CITY OF BELOIT

REPORT TO THE BELOIT LANDMARKS COMMISSION

File Number: COA-2017-26

Location: 703 Park Avenue

Fig. 8

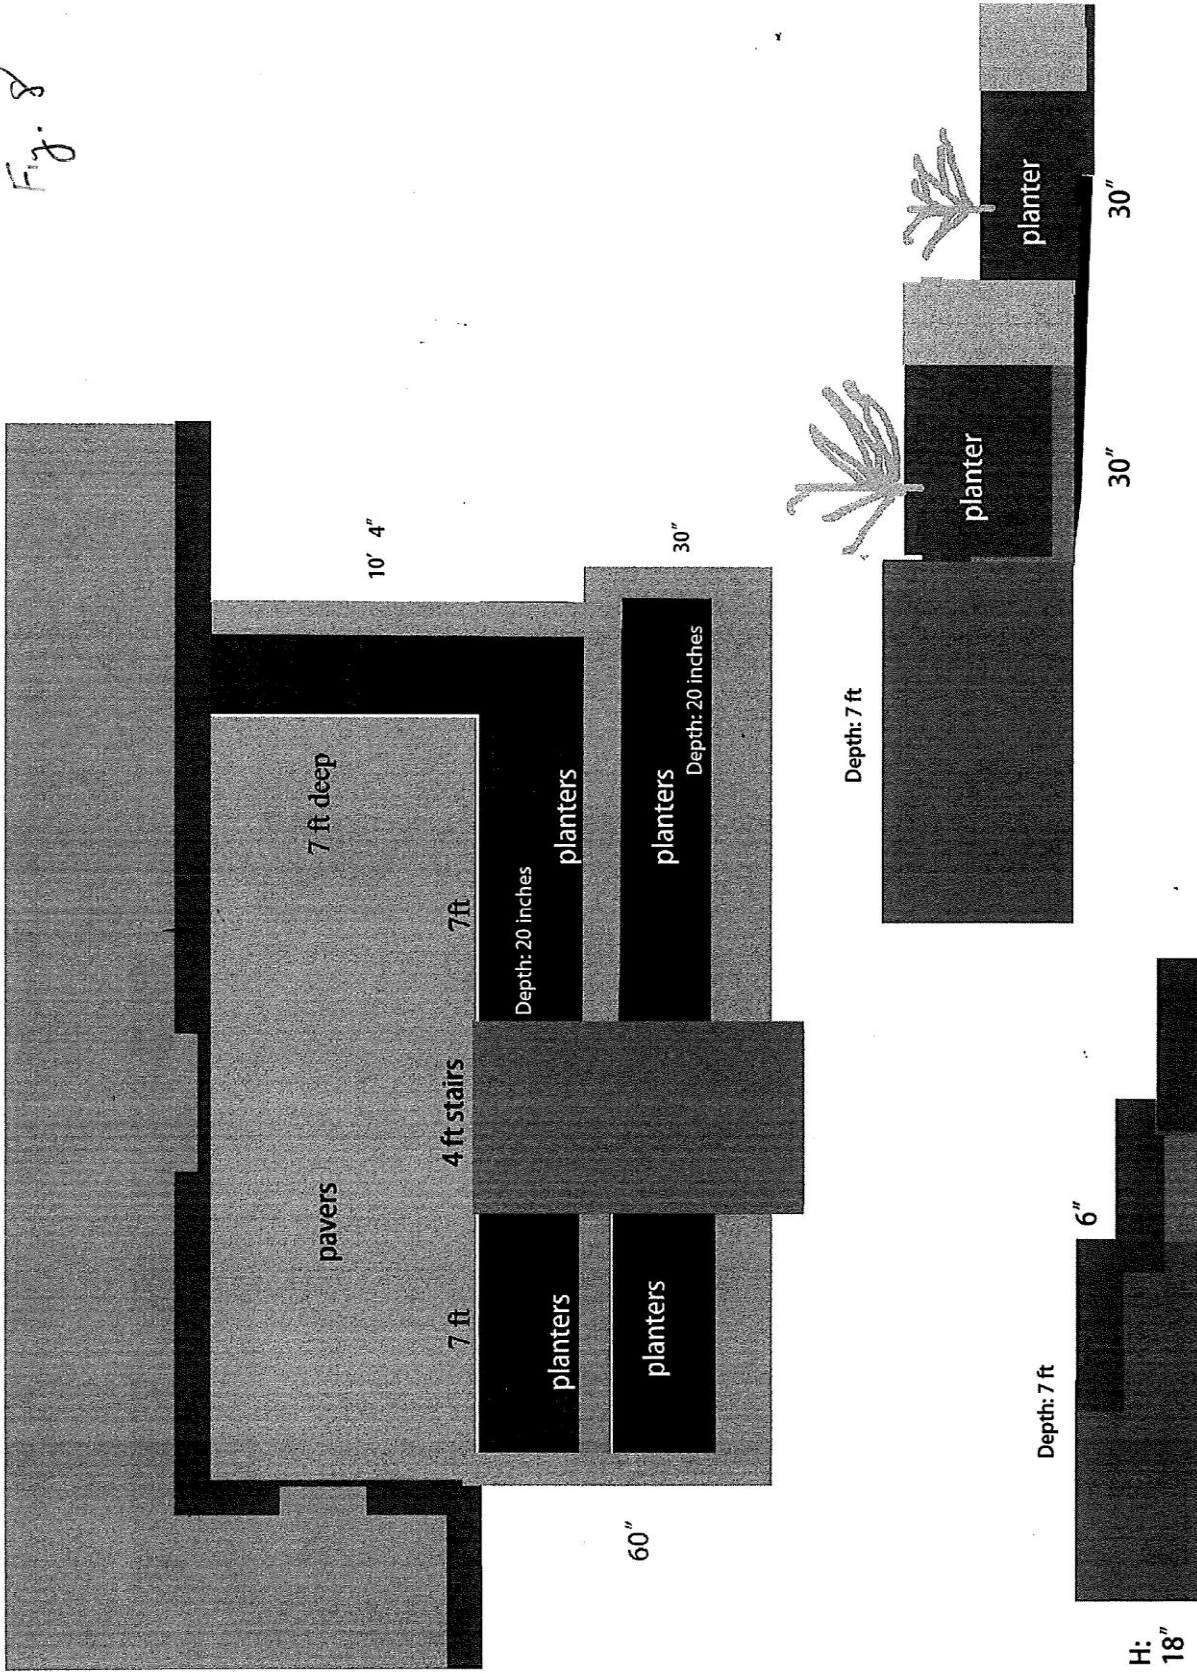
- Addition of the second layer of gravel, limestone steps, and pavers
 - Constructing the two limestone garden planter boxes at the base of the newly constructed terrace. The intent is to create a cascading look and feel to the terrace desired by the applicant. The planter boxes will be constructed from the same material as the terrace, and will be located on each side of the inset stairway at the base of the terrace (see Figure 8).
